ADDENDUM NO. 2

Americans with Disabilities Act (ADA) Self-Evaluation and Transition Plan

Accessibility Evaluation Report

Report No.: 072516

Fire Station #2 – 1150 W I St.

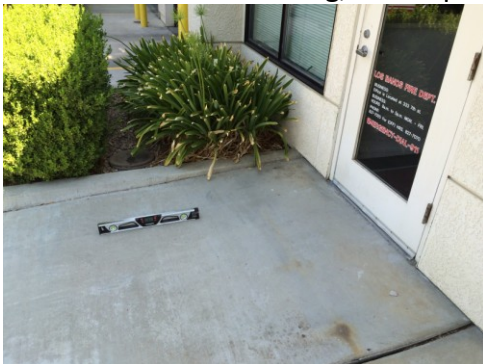
Finding #2

The existing accessible parking stall must be re-striped for a van accessible stall with the access aisle on the passenger side of the stall. Also complete parking signage and "Tow Away" sign must be provided.

Finding #3

The landing at the front entrance is not level to at least 5' from the door. To be considered a level landing, the slope in all directions must be less than 2%.

Finding #7

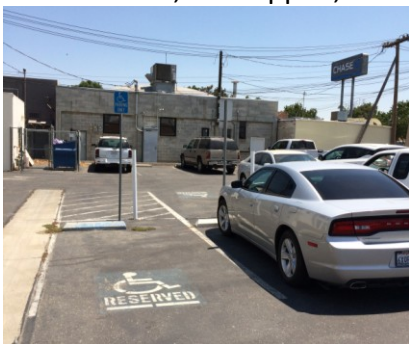
The stairs on the opposite side of the ramp have non-compliant handrails and no visual stripping on the nose of the steps.

I recommend providing compliant handrails on both sides and painting 2”-4” visual strips (yellow) on the nose of each step. CBC 11B-504; 11B-505.

Current location of the 3 accessible stalls.

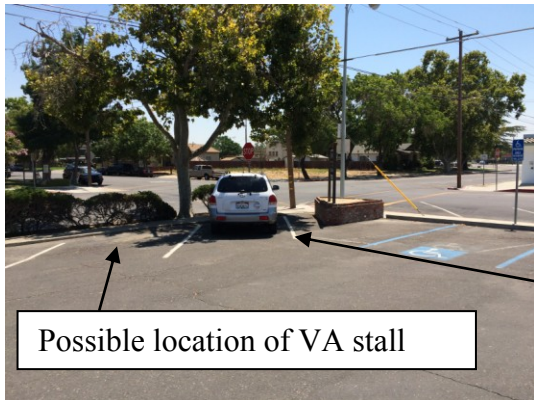
The parking lot has 34 marked stalls including 3 accessible stalls, however the 3 accessible stalls require individuals to travel behind parked cars other than their own to get to the public sidewalk. *CBC 11B-502.7.1 Arrangement.*

A possible solution would be to re-locate the van accessible stall where the access aisle is near the corner so individuals can travel to the sidewalk. The access aisle can be shared with the stall on the right and the third stall can be arranged so the individual can travel down the driveway and not behind any parked cars.

Stripe access aisle to provide POT at the corner and shared with the accessible stall on the right.

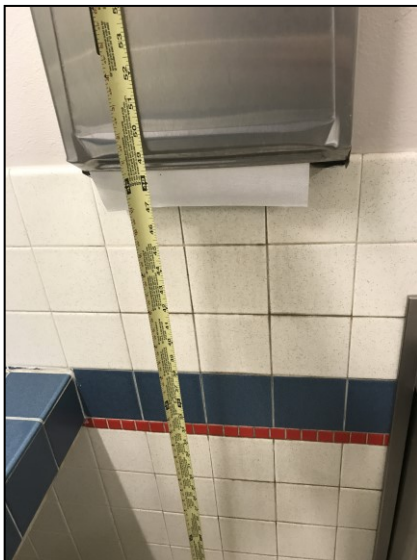
The Lavatory counter's in both restrooms are mounted higher than the maximum 34" off the floor. The Men's is mounted at 34 ½" and the Women's is at 35".

Possible Solution:
Re-mount both lavatory
counters or raised floor
levels.

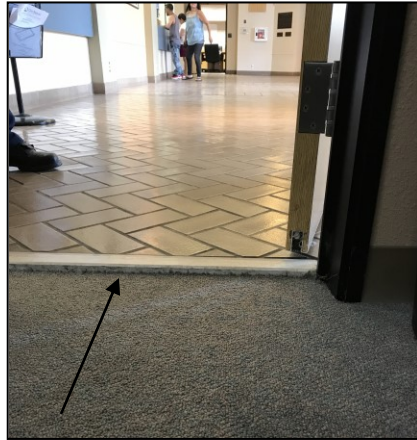
Both Men's and Women's accessible public restrooms have doors that exceed the maximum opening force of 5lbs of pressure.

Possible Solution:
Adjust or replace door closers.

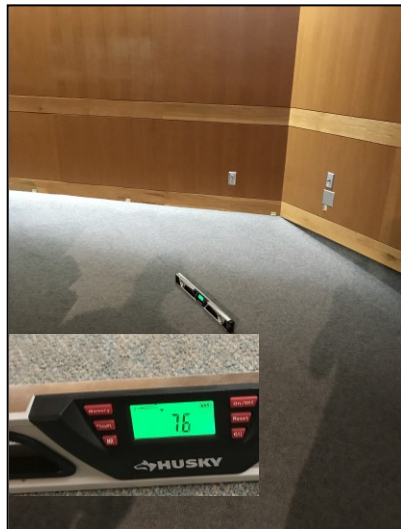
There is no level designated accessible seating area in the Council Chambers.

Possible Solution:
Provide a compliant area in the council chambers to provide a minimum of two-wheel chair spaces.

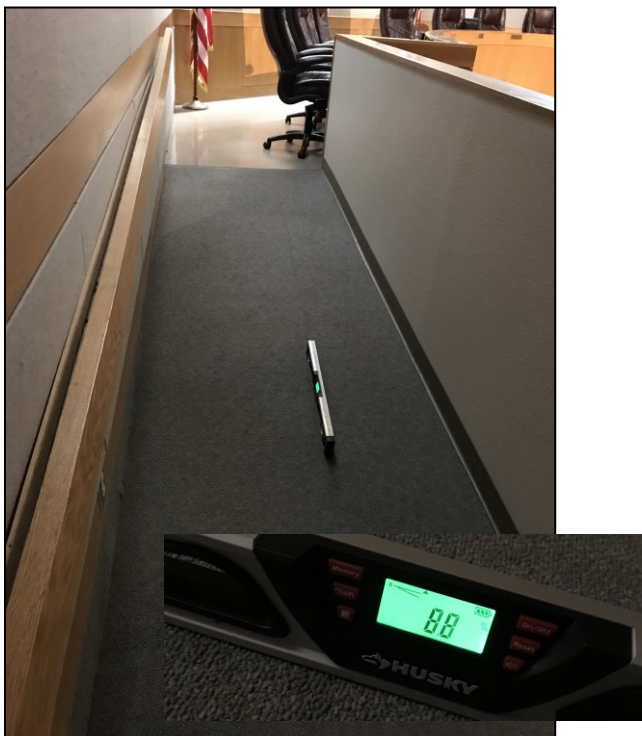
A permanent or portable assisted listening device must be available for individuals with hearing impairments.

Possible Solution:
Provide a minimum of two assisted listening devices and include a sign indicating this is available.

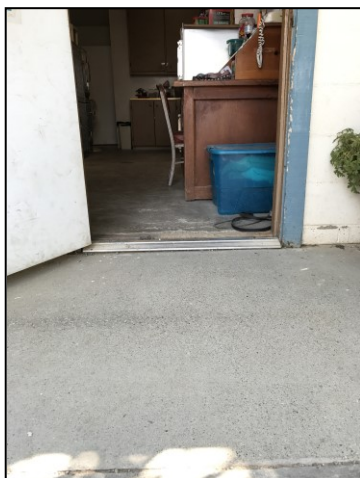
The accessible path of travel (POT) from the public office modular to the kennels does not exist. There must be a compliant POT from the bottom of the office ramp to the kennels. OR provide equal facilitation at the kennel office area.

Possible Solution:
Provide a compliant POT 48”
wide from the bottom of the
ramp to the kennel entrance.
OR provide equal office space
for the public at the kennel.

Finding #38

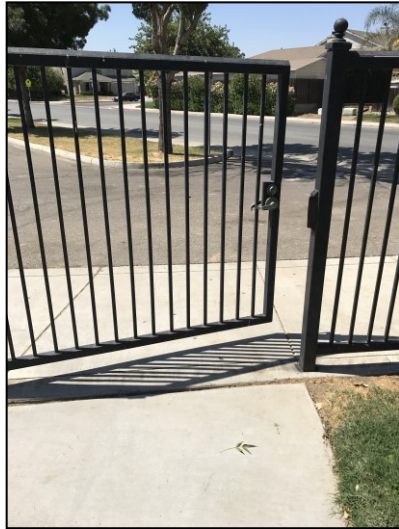
Code Reference Section:
CBC – 11B-404.2.10 –
Smooth push surface
11B-404.2.7 handle
ADAS – 404.2.10 – Smooth
push surface
404.2.7 handle

Possible Solution:
Install a smooth 10" push plate
at the bottom of the gate.
Install a pull handle on the
inside of the gate.

Finding #43

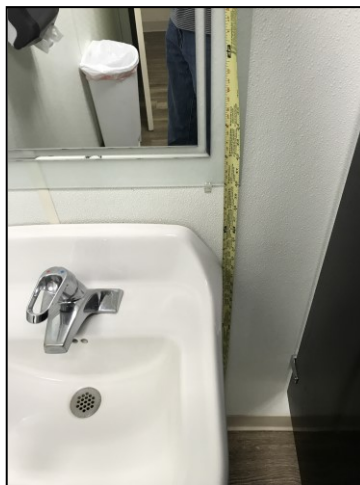
The Women's restroom has several issues that need to be addressed.

- Provide the correct Women's door and wall sign. 11B-703.7.2.6.3.

- The clearance to the lavatory does not provide the minimum 36" wide clear floor space. 11B-606.2; 305.

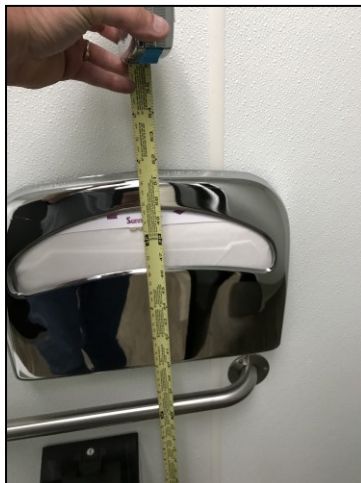
The Men's restroom has several issues that need to be addressed.

- Provide the correct Men's door and wall sign. 11B-703.7.2.6.3.

- The toilet is not centered between 17"-18" (21 1/2") from the side wall. 11B-604.2.
